Access Compliance Report

Public Rights-of-Way

(Curb Ramps)

Intersection ID: N/A	Main Street: BEREWICK COMMONS PKY	Cross Street: KELTON HILL LN	Location: NW
ADA ID: 95039229667B	Ramp Type: PerpDiag	Initial Pass/Fail: Fail	Overall Compliance: No
Severity Score: 10			
Codes/Mitigation Info/Possible Solution		Field Measurements/Component Compliance

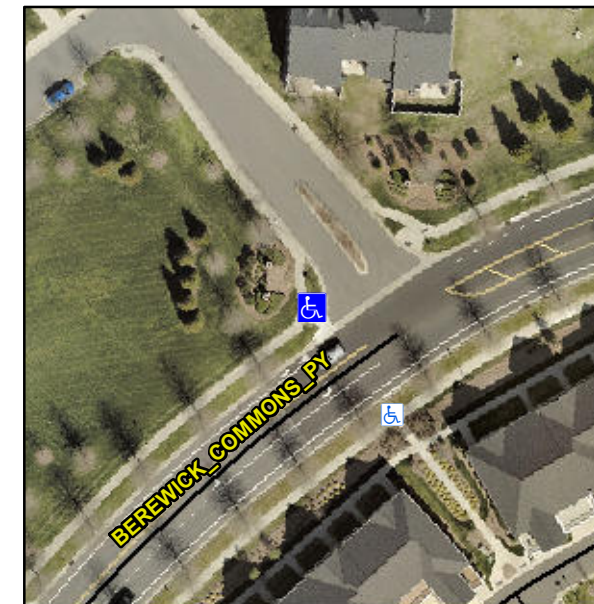
R304.5.1, R304.5.3

Compliance	Description	Data	Compliance	Description	Data
N/A	Ramp Length (in)	97.0	Yes	Ramp Slope (%)	7.5
No	Ramp Width (in)	42.0	No	Ramp XSlope (%)	2.4
N/A	Flare Type LT	N/A	N/A	Flare Type RT	N/A
N/A	Flare Slope LT (%)	N/A	N/A	Flare Slope RT (%)	N/A
N/A	Flare Traversable LT?	N/A	N/A	Flare Traversable RT?	N/A
N/A	Landing Length (in)	N/A	N/A	DWS Provided?	N/A
N/A	Landing Width (in)	N/A	N/A	DWS Contrast?	N/A
N/A	Landing Slope (%)	N/A	N/A	DWS Length (in)	N/A
N/A	Landing X Slope (%)	N/A	N/A	DWS Full Width?	N/A
N/A	Landing Curb? (Y/N)	N/A	N/A	DWS Offset (in)	N/A
N/A	Shared Landing?	N/A			
N/A	Gutter Ponding?	N/A	N/A	Gutter Slope (%)	N/A
N/A	Gutter Lip Ht (in)	0.5	N/A	Gutter X Slope (%)	N/A
N/A	Painted X Walk1?	No	N/A	Painted X Walk2?	No
	X Walk 1 Direction	To SE		X Walk 2 Direction	To NE
N/A	X Walk 1 Width (in)	N/A	N/A	X Walk 2 Width (in)	N/A
	X Walk 1 Slope (%)	4.7		X Walk 2 Slope (%)	1.2
	X Walk 1 X Slope (%)	2.4		X Walk 2 X Slope (%)	5.3

Remove & Replace Curb Ramp With Two New Directional Ramps or Equivalent.
